Docket No. 50-220

Change No. 10
License No. DPR-17

NIAGARA MOHAWK POWER CORPORATION

CHANGE NO. 10 TO TECHNICAL SPECIFICATIONS

FIGURE 3.1.7.a MAXIMUM ALLOWABLE AVERAGE PLANAR LHGR
APPLICABLE TO FUEL TYPE INITIAL CORE

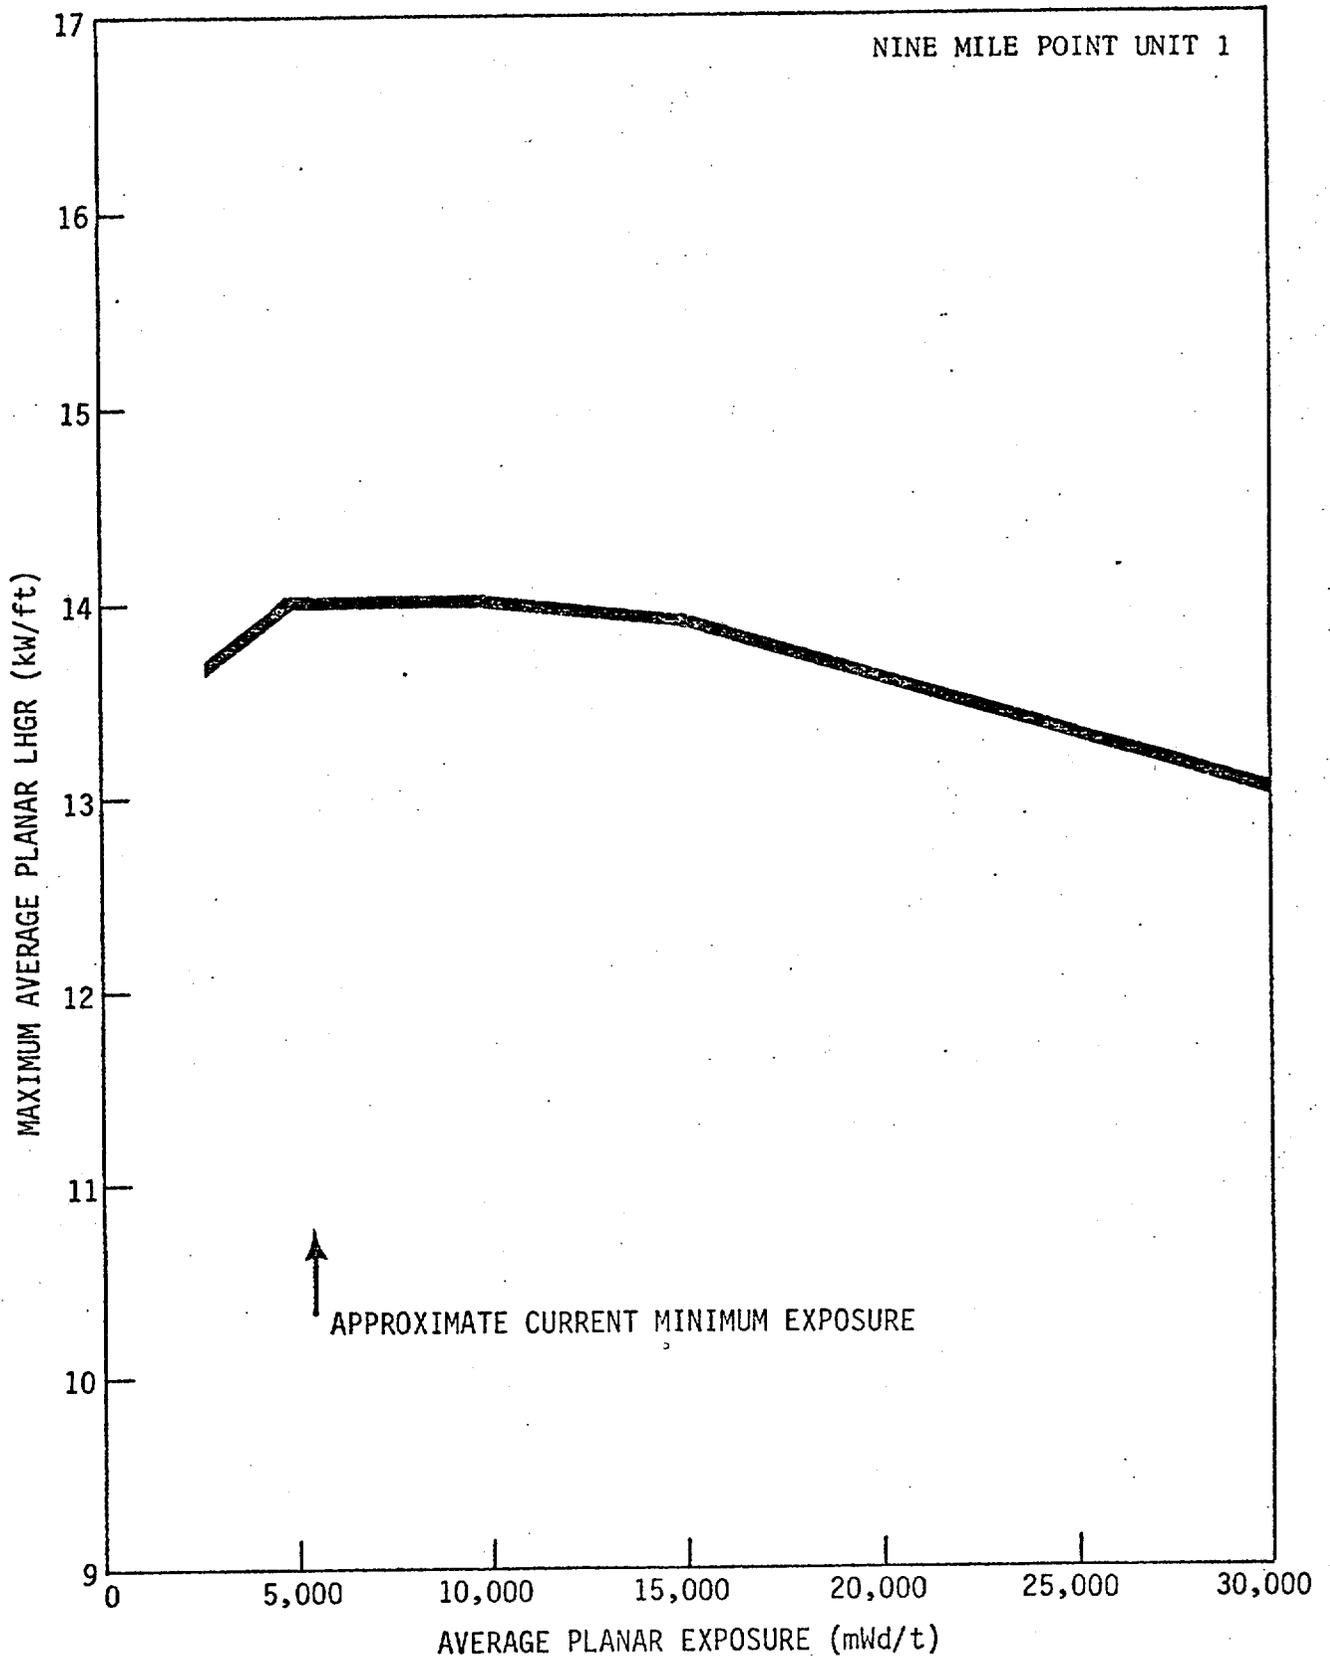
1. Delete Figure 3.1.7 and replace with the attached Figures 3.1.7a, b, c, and d. Under the Limiting Condition for Operation 3.1.7, delete the phrase in the last sentence in paragraph a. of the Specification "Figure 3.1.7" and replace with the phrase Figures 3.1.7a, b, c, and d.
2. Replace the third through sixth paragraphs of the Bases 3.1.7a with the following: "The maximum average planar LHGR curves for the various fuel types in the core shown in Figures 3.1.7a, b, c, and d are based on calculations using the models described in the GE reports NEDO-10735, as modified by the GE report NEDO-20181 and the GE letter of December 12, 1973, to V. Moore from J. Hinds, 'Plant Evaluation with GEGAP-III'."
